HFS ARCHITECTS

Addendum No. 02

Project:	Provo DWS - HVAC System Upgrade & Ceiling Replacement	Date:	18 February 2005
Address:	1525 North Freedom Boulevard	Project No.:	0426.01
City, State:	Provo, Utah	Owner No.:	04210920
Owner:	DFCM	Agency:	Department of Workforce Services

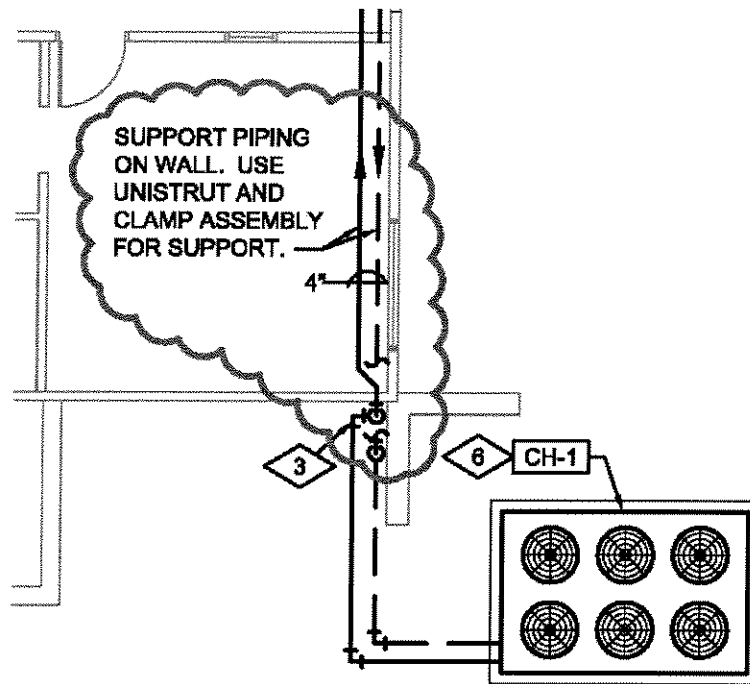
Item No.	Section or Sheet No.	Description
1-15	AE101/AE102	FINISH LEGEND: Revise <i>Finish A</i> to read <i>"EXISTING BRICK WALL FINISH TO REMAIN, EXISTING PAINTED CMU WALL TO BE RE-PAINTED"</i> .
1-16	MH101	MAIN LEVEL MECHANICAL PLAN Delete fire smoke damper from supply duct penetrating east stairwell.
1-17	MH201	MAIN LEVEL MECHANICAL PIPING PLAN Change the run of the chilled water piping to be supported by the north wall. Piping shall run one above the other. See figure below:

MAIN FLOOR PHASING
PROVO WFS PROJECT - ADDENDUM 02

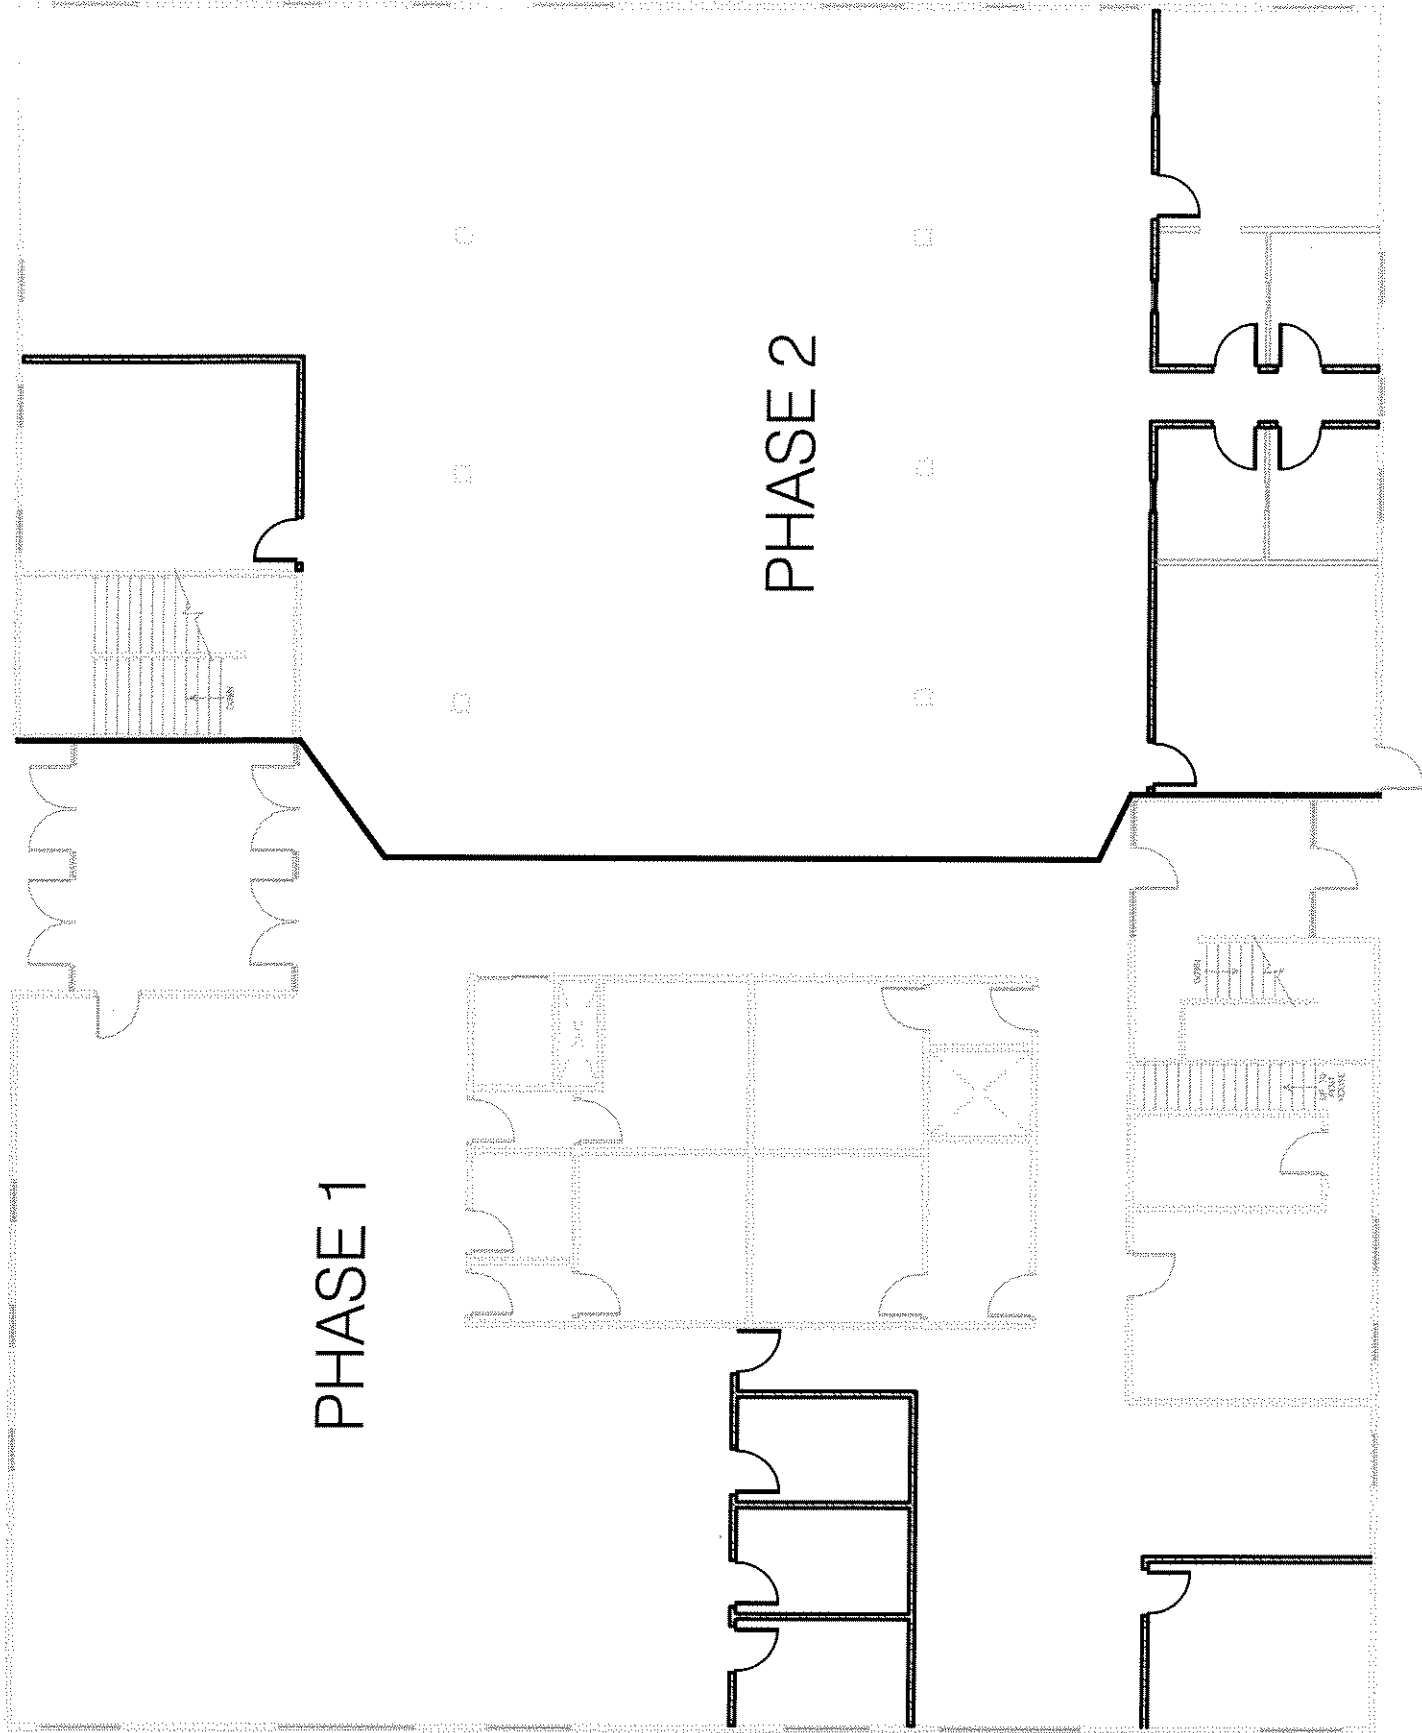
| 1-2 | | See the attached drawings Lower Floor Phasing and Main Floor Phasing for the phasing sequence for this project. |

**REVISED MAIN FLOOR DEMOLITION PLAN
PROVO WFS PROJECT - ADDENDUM 02**

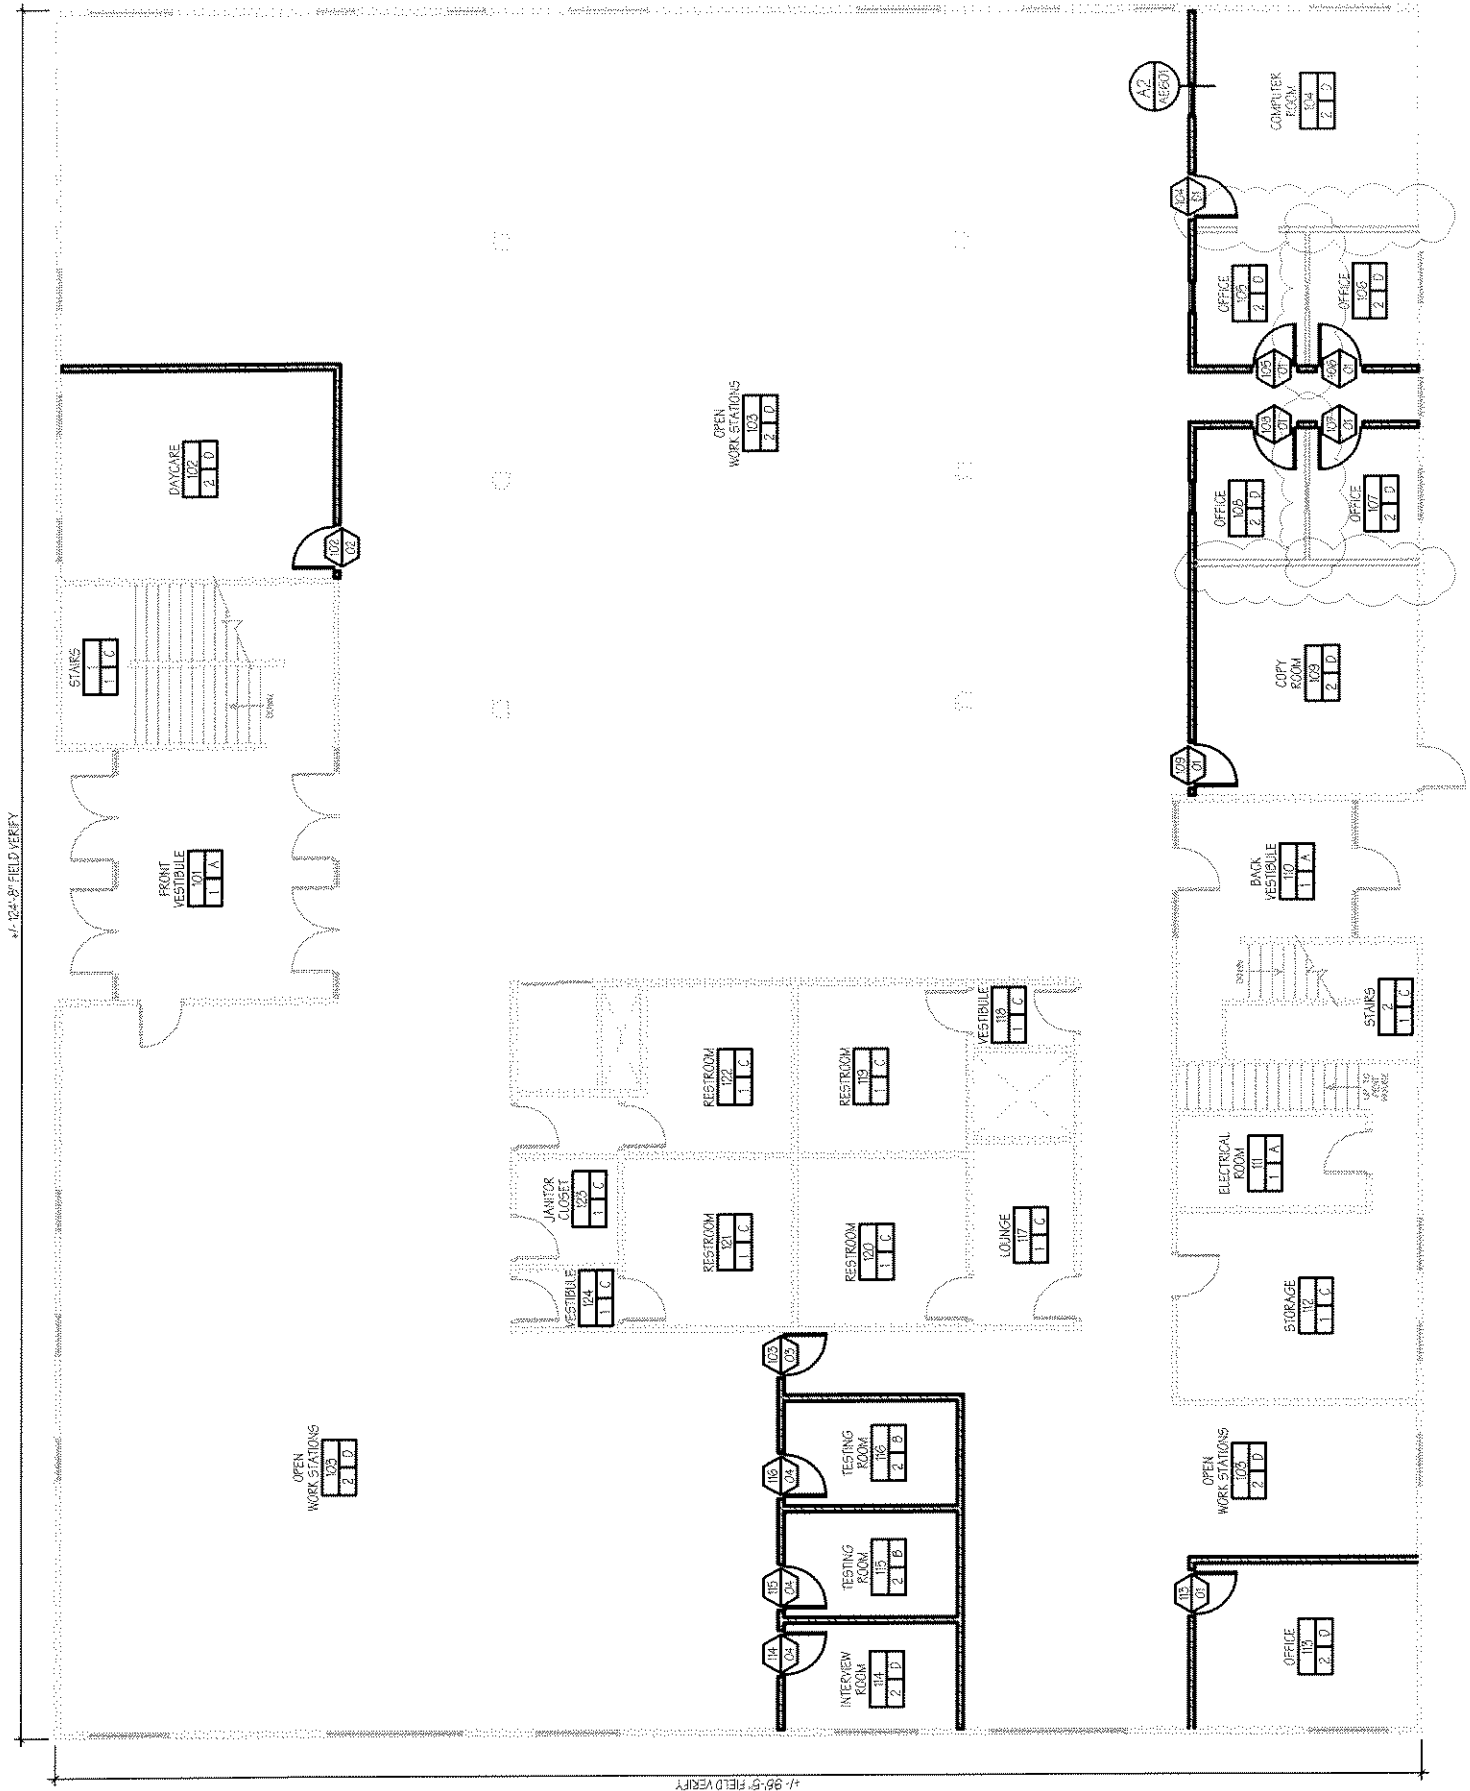
1-14	AD101/AE101	Revise each plan at OFFICE 113 as shown on the attached drawings <i>Revised Main Floor Demolition Plan</i> and <i>Revised Main Floor Plan</i> .
------	-------------	--

Photograph 03: Canopy at front entry (West) to be re-roofed.

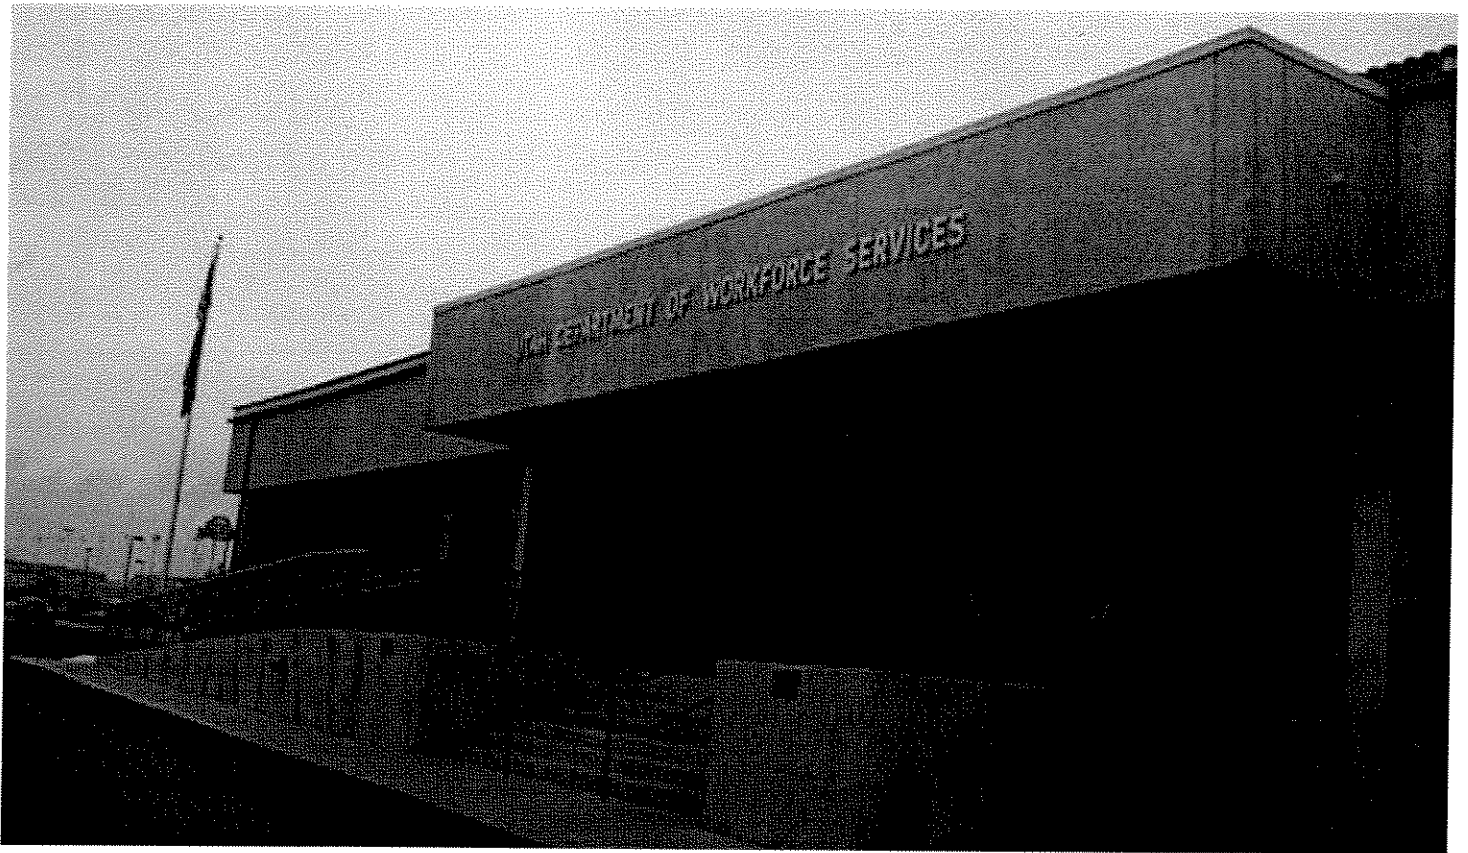
| 1-4 | Additional Scope | The re-roof of the canopies at the front (west) and back (east) entries have been added to the project. Remove existing ballast and single-ply membrane. Replace with new single-ply membrane as specified. Front canopy is 160 square feet with 48 lineal feet of parapet and 40 lineal feet of existing metal flashing to remain (slide new membrane under), existing tapered insulation (to remain) slopes from the center to north/south sides. Back canopy is 320 square feet with 56 lineal feet of parapet and 40 lineal feet of existing metal flashing to remain (slide new membrane under), existing tapered insulation (to remain) slopes from north to south. Extend |

Item No.	Section or Sheet No.	Description
		membrane over parapet wall on three sides, (parapet height varies from 12" to 20" with slope of insulation – assume 1/4"/foot). Provide new kynar-coated parapet cap similar to Detail A3/AS501 (issued in Addendum 01). See photographs 3-6.
1-5	Clarification	Access to the roof parapet ...
1-6	Clarification	See the attached drawings Existing Lower Floor Demountable Walls To Be Painted Existing Main Floor Demountable Walls To Be Painted for the locations of these walls.
1-7	Clarification	Any roof sheathing removed by the contractor as a result of the installation of the new boiler shall be part of the base bid.
1-8	Clarification	North wall of roof top mechanical enclosure has a surface mounted electrical disconnect which will need to be removed and the replaced to run new roof membrane up the wall, see photograph #01.
1-9	Clarification	Addendum 01, attached DETAIL A4/AS501 : Provide as part of the assembly an OPEN-FACED DOWNSPOUT (SMACNA FIG 1-32G) and SPLASH PAN (SMACNA FIGURE 1-36) at each new scupper.
